LINE OF BUSINESS AUDIO SYSTEMS

# SERVICE NEWSLETTER

Published by:  
Service Department Portable Audio

# SERVICE NEWSLETTER

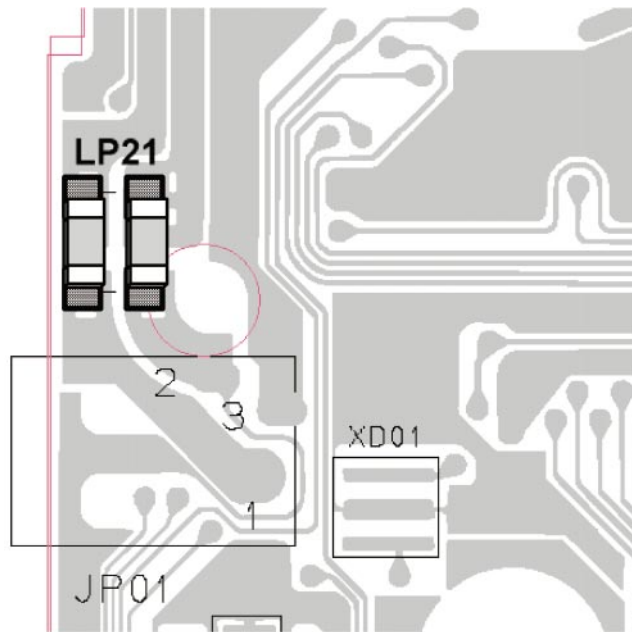
**SYMPTOM** : **IRIS CODE 2 1 2 1**  
Ni-Cd battery pack cannot be recharged.

**CURE** : The ACTUATING PIN-CHARGE (item 431) does not connect properly. The pin has to be replaced by a modified one – 4822 535 10522.

**REMARKS** : New part has been used in production from week 9809 onwards.

FIG. 1 CUT-OUT VIEW OF SPEAKER BOX-E

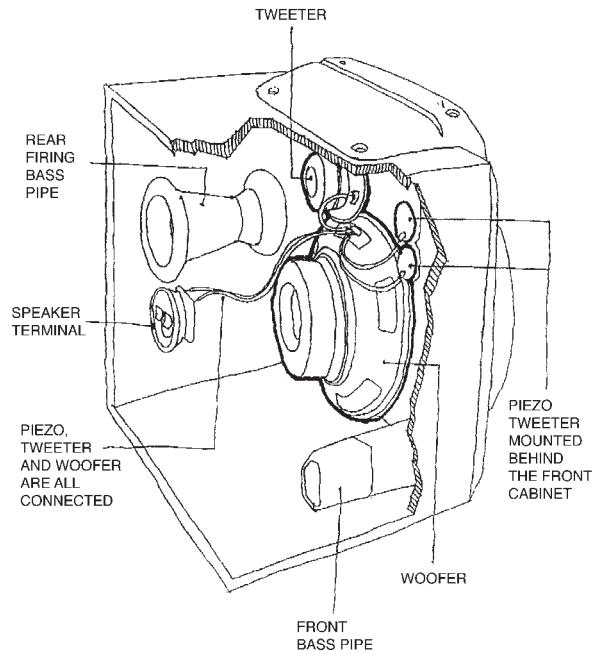
**INFORMATION :** The 2 tweeters at the upper part of the 4-way Loudspeaker Box are dummies and for ornamental reasons only. The piezo tweeters are mounted behind the Front cabinet (see fig. 1) instead of the top part. There is no acoustical difference between mounting piezo tweeters on top or on front.

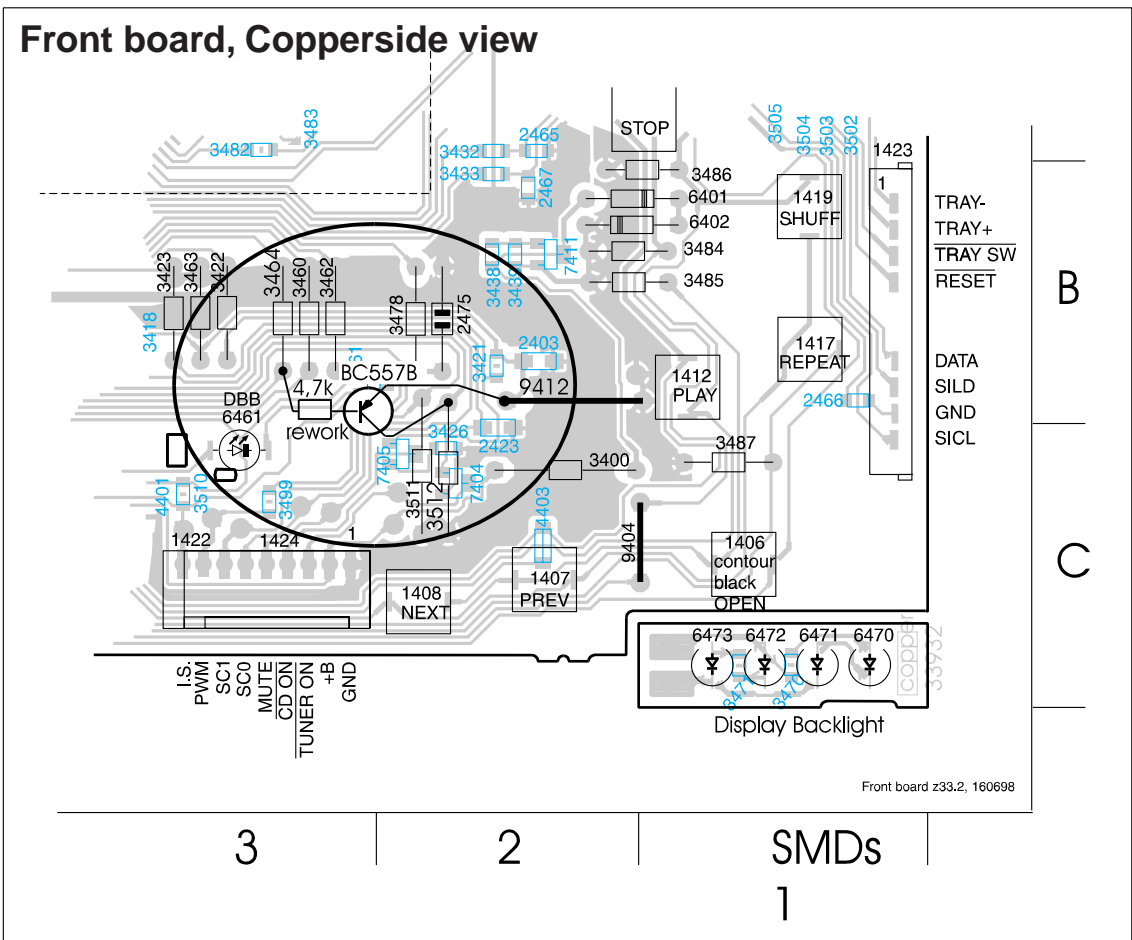
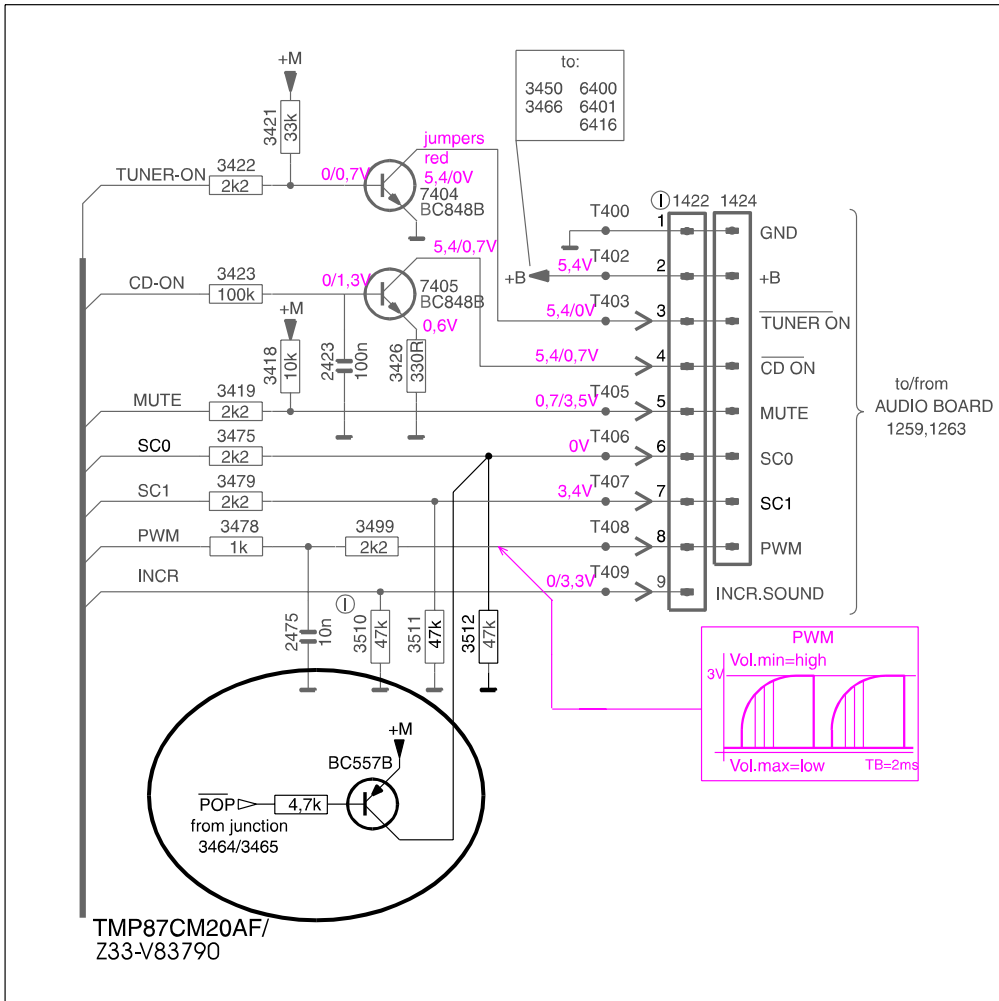
CURE : The problem is caused by a software bug.  
There are two solutions available:

Add a transistor BC557C (4822 130 42231) and a resistor 4.7kΩ  
(4822 116 52283). Connect the collector (C) of BC557B to the  
junction of 3512 and 3475, the emitter (E) to +M and the base (B) via  
a 4.7kΩ resistor to junction of 3464 and 3465.

For details on this rework, see circuit and layout diagram below.

Replace microprocessor IC 7400 by 4822 209 17228.

REMARKS : Short term solution has been implemented in production from week  
9830 onwards. New microprocessors will be used from week 9842  
onwards.

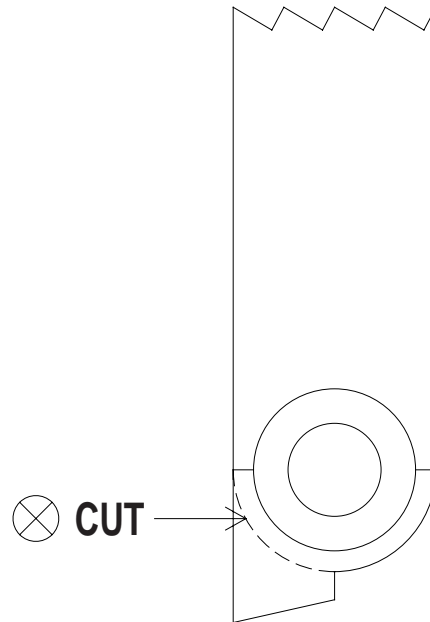
**INFORMATION** : The Handle Bracket Left (pos. 34, 4822 498 10501) is no longer available as service spare part. We suggest to use Handle Bracket Right (pos. 36, 4822 498 10502) as a substitute.  
The stopper end has to be cut as shown in the diagram below.

### INFORMATION : Cleaning and lubricating instructions

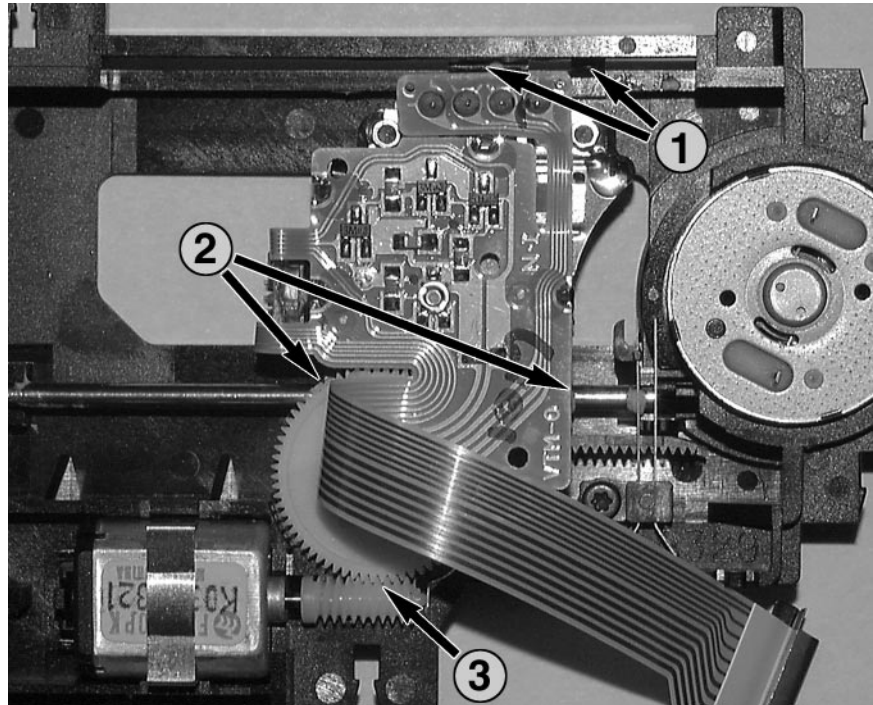
Before greasing the mechanism first remove the old grease from the mechanism. Use a cotton swab dipped in alcohol to clean the mechanism.

1. Clean the lower and upper sledge guidance plane (optical pick-up).
2. Clean the spindle shaft.
3. Clean the area between the worm gear, idler wheel and clamping spring.

1. Put onto the upper sledge guidance plane one dot of grease on each side of the sledge. Move the sledge to the inner and outer position to spread the grease.  
Put onto the lower sledge guidance plane one dot of grease on each side of the sledge. Move the sledge to the inner and outer position to spread the grease.
2. Put onto the spindle shaft one dot of grease on both sides of the sledge. Move the sledge to the inner and outer position to spread the grease.
3. Put one dot of grease between the worm gear and the clamping spring.

### INFORMATION : **Cleaning and lubricating instructions**

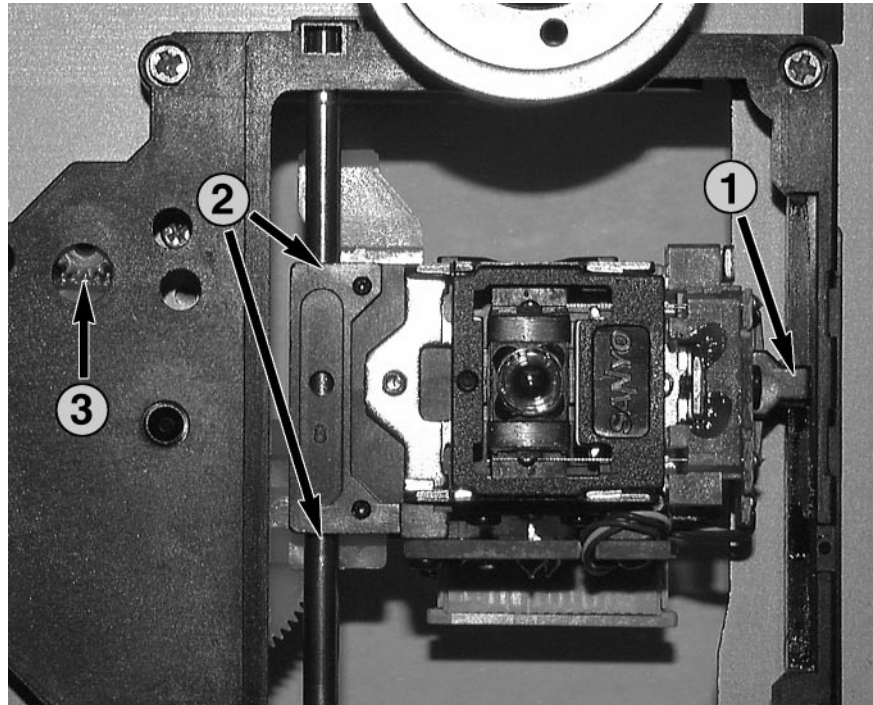
Before greasing the mechanism first remove the old grease from the mechanism. Use a cotton swab dipped in alcohol to clean the mechanism.

1. Clean the lower and upper sledge (optical pick-up) guidance plane.
2. Clean the spindle shaft.
3. Clean the area between the toothed bar and idler wheels.

1. Put onto the upper sledge guidance plane one dot of grease on each side of the sledge. Move the sledge to the inner and outer position to spread the grease.  
Put onto the lower sledge guidance plane one dot of grease on each side of the sledge. Move the sledge to the inner and outer position to spread the grease.
2. Put onto the spindle shaft one dot of grease on both sides of the sledge. Move the sledge to the inner and outer position to spread the grease.
3. Put one dot of grease between the toothed bar and the idler wheels.

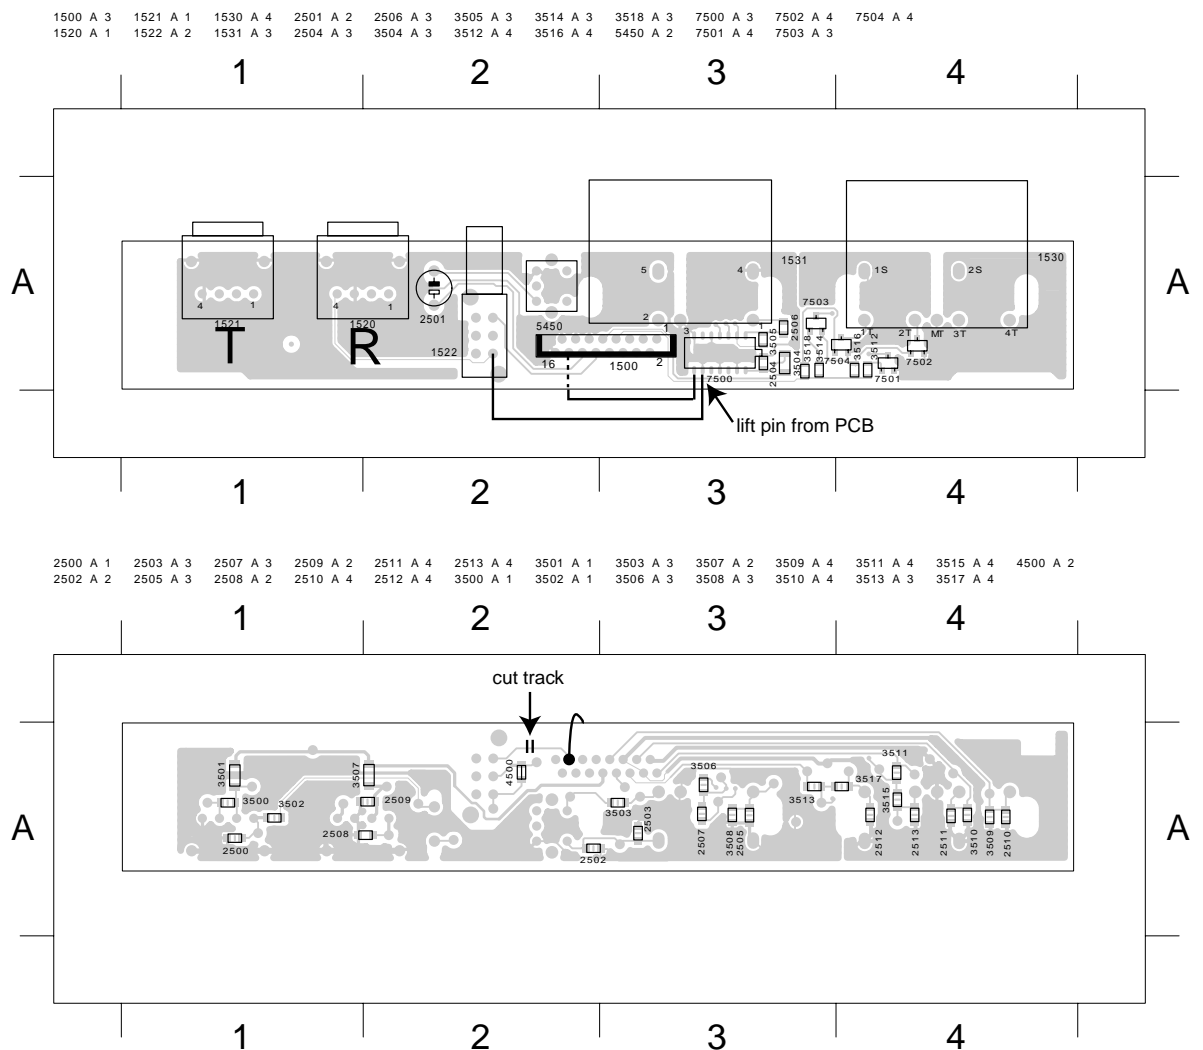
**SYMPTOM :** IRIS CODE 2 5 6 6  
Bad recording when using optical input of set

1. Replace PLR102 by TORX174 (Toshiba) with service codenumber 4822 130 91224. C2508 has to be replaced by a short circuit to ground. The risetime specifications of this device are <30ns.
2. Use one of the free inverter ports of device 74HCU04N (item 7500) to improve the optical in signal. This can be done as follows:
  - Connect output 4 of optical device to pin 9 of IC7500.
  - This pin must be lifted from the PCB.
  - Connect pin 8 of IC7500 to pin 14 of connector 1500.
  - Interrupt copper track between pin 14 of connector 1500 to pin 4 of switch 1522 (not mounted).

With this solution, steep flanks will be created on the signal.  
Note that inverting is no problem for a biphase signal.  
See also picture of the modified PCB below.

**REMARKS :** An improved connector PCB will be introduced in course of production. See Service Information A98-250 (4822 725 25244).

Portion of Circuit diagram

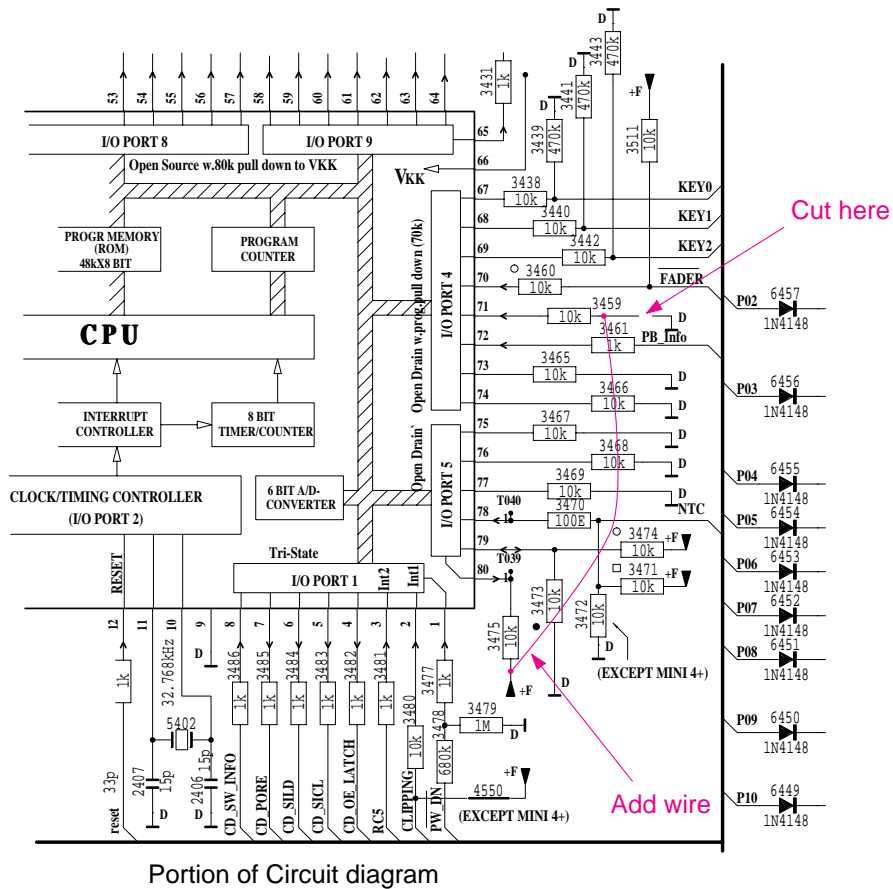
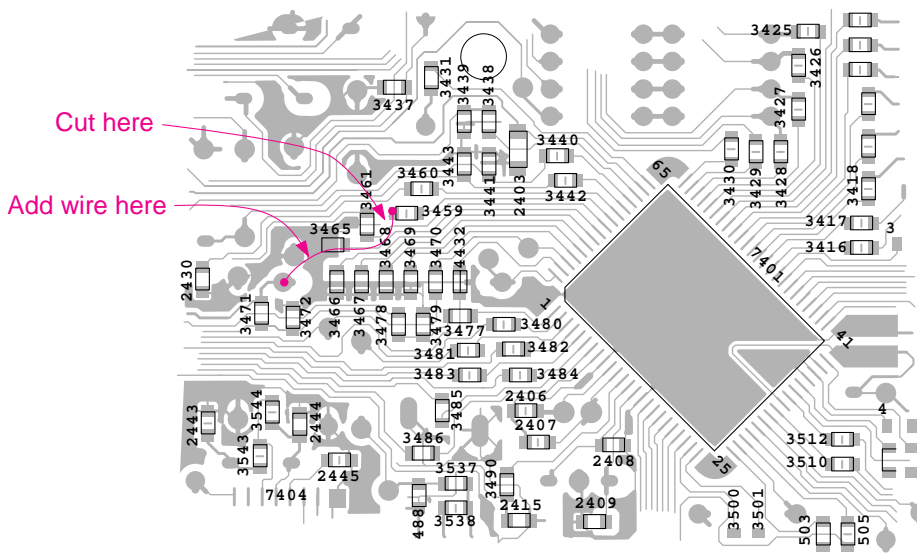
CURE : The phenomenon is caused by mismatch of software and hardware timing. The problem can be solved by the following hardware modification on the front board:  
1. Cut a copper track between resistor 3459 (10kΩ) and ground D.  
2. Connect a short wire between resistor 3459 to +F supply (+5V).  
For details on this rework, see circuit and layout diagram below.
